## **ARCHITECTURAL BUILDING CODE SURVEY**

# **TOWN OF VIENNA PARKS AND RECREATION FORMER FAITH BAPTIST CHURCH**

1 LIFE SAFETY - FIRST FLOOR PLAN  
G-101 SCALE: 3/32" = 1'-0"

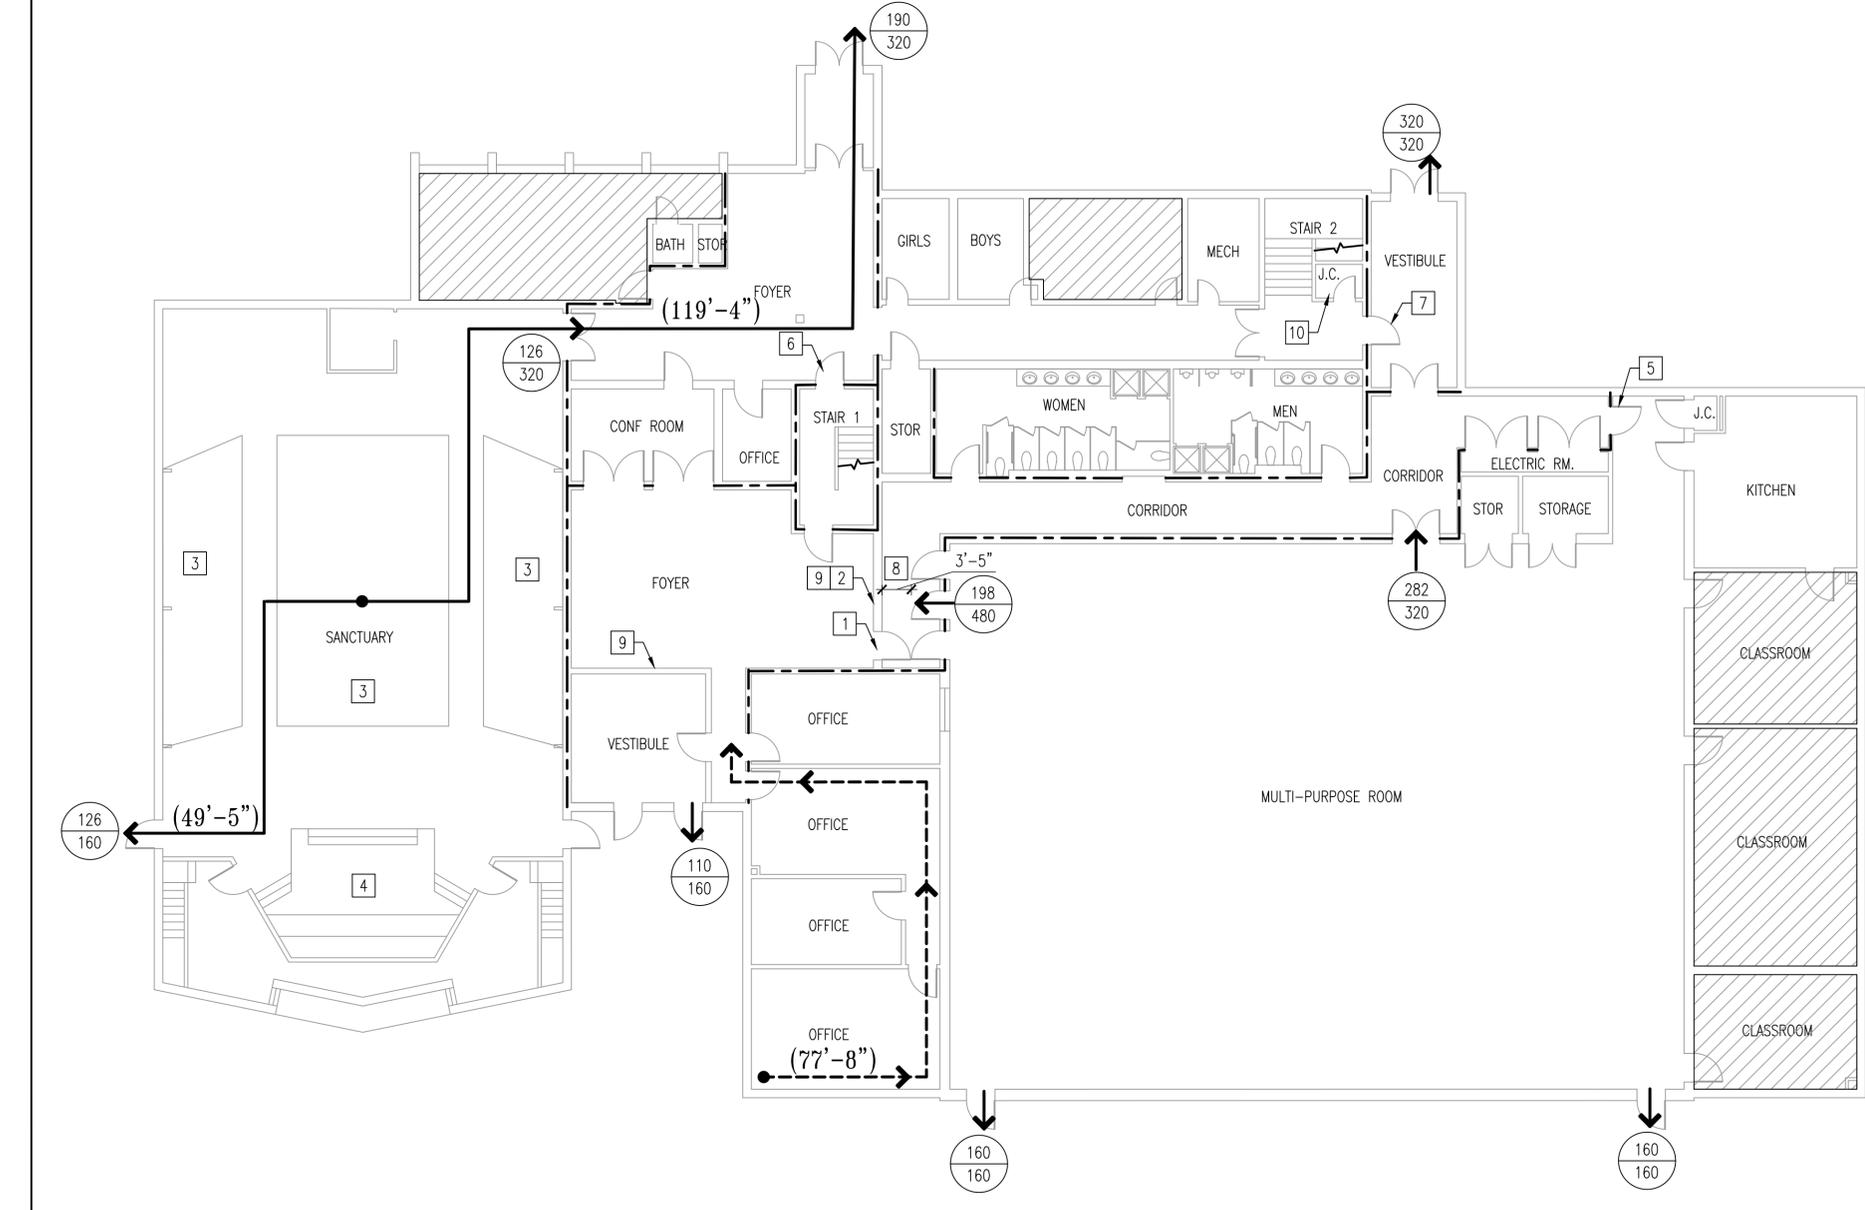
- 1 DOOR NOT PERMITTED TO SWING TOWARD THE MULTIPURPOSE ROOM.
- 2 ADDITIONAL DOOR IS REQUIRED IN THIS WALL TO MEET MINIMUM REQUIRED EGRESS CAPACITY.
- 3 SANCTUARY SEATING - BENCHES WITH OCCUPANT LOAD CALCULATED AT 1 PER 18" OR BENCH LENGTH.
- 4 EXISTING STAGE WITHOUT PROSCENIUM (ALTAR).
- 5 NOT A REQUIRED MEANS OF EGRESS
- 6 OCCUPANT LOAD FROM SECOND STORY = 31. EGRESS THROUGH FOYER.
- 7 OCCUPANT LOAD FROM SECOND STORY = 31. EGRESS THROUGH VESTIBULE.
- 8 MINIMUM 48" CLEAR FROM DOOR OPEN AS SHOWN TO OPPOSITE WALL NOT MET.
- 9 EXISTING WALLS DIVIDE WHAT APPEARS TO HAVE BEEN A RATED EGRESS CORRIDOR.
- 10 JANITOR'S CLOSET (OR ANY STORAGE OR OTHER FUNCTION) NOT PERMITTED IN STAIRWELLS.

**1 LIFE SAFETY - SECOND FLOOR PLAN**  
 G-101 SCALE: 3/32"=1'-0"

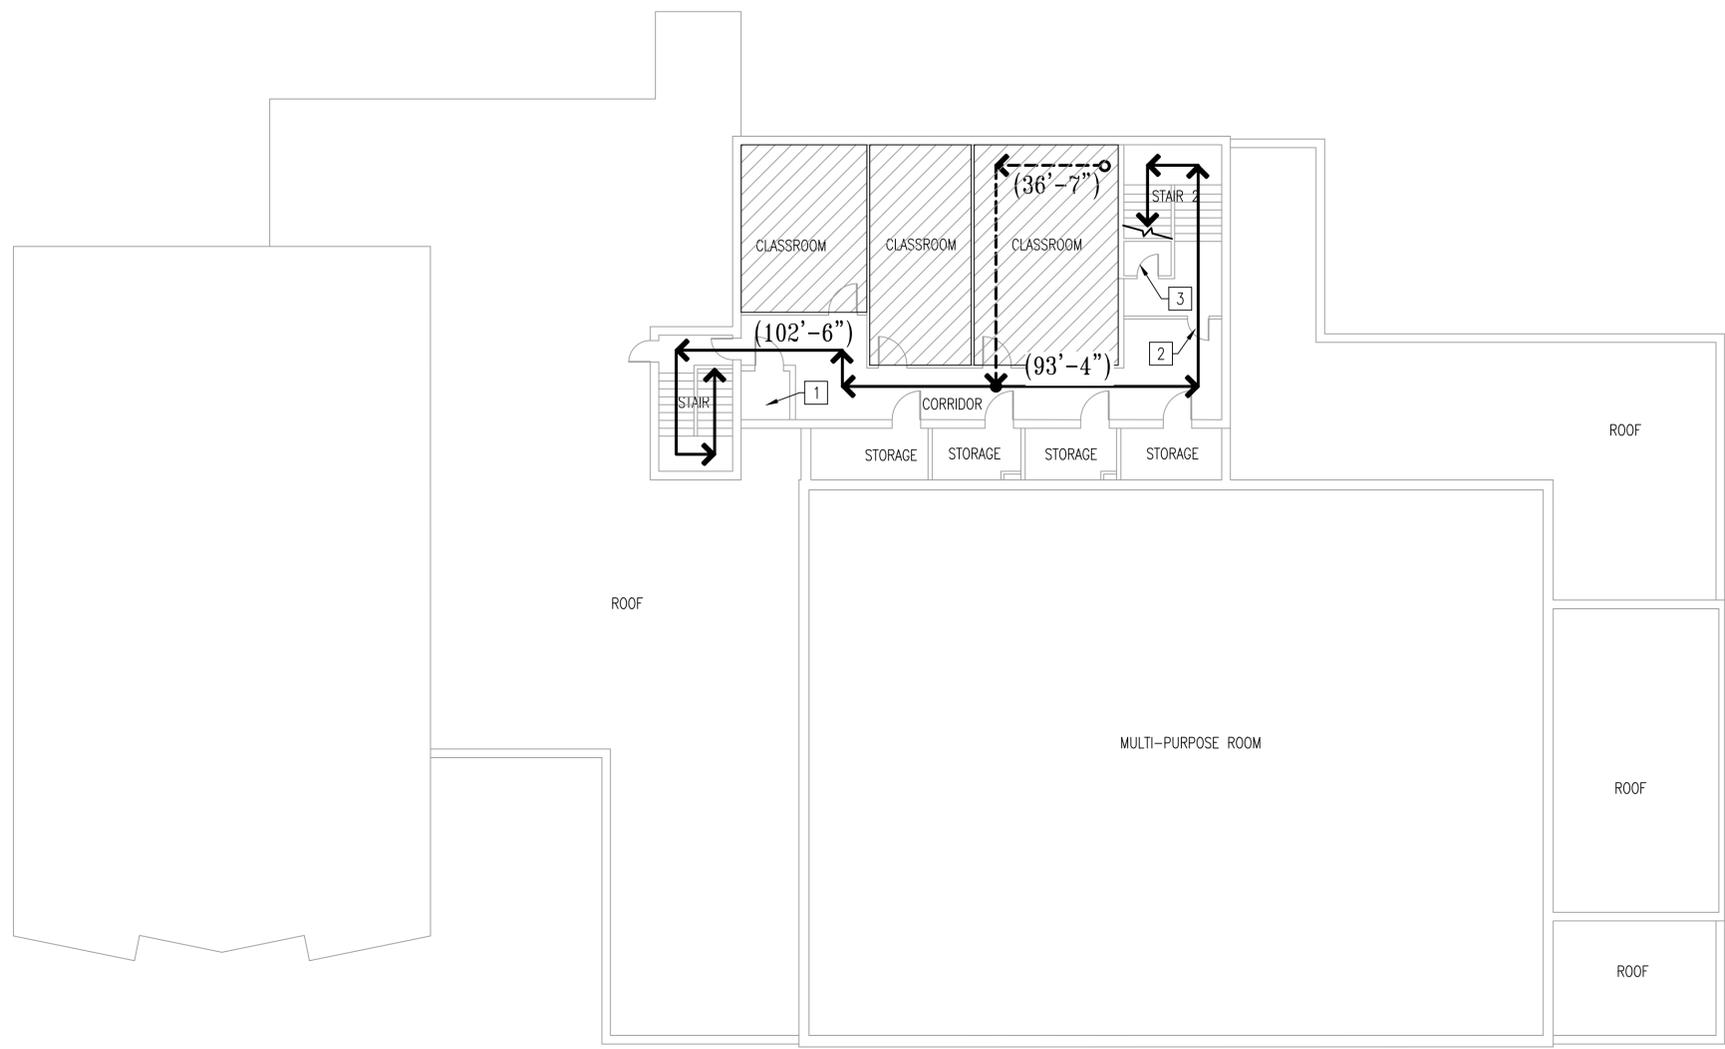
- 1 NON-RATED STORAGE ROOM NOT PERMITTED WITHIN RATED EGRESS CORRIDOR.
- 2 WALL DOES NOT APPEAR TO BE RATED AS REQUIRED FOR STAIR ENCLOSURE.
- 3 JANITOR'S CLOSET (OR ANY STORAGE OR OTHER FUNCTION) NOT PERMITTED IN STAIRWELLS.
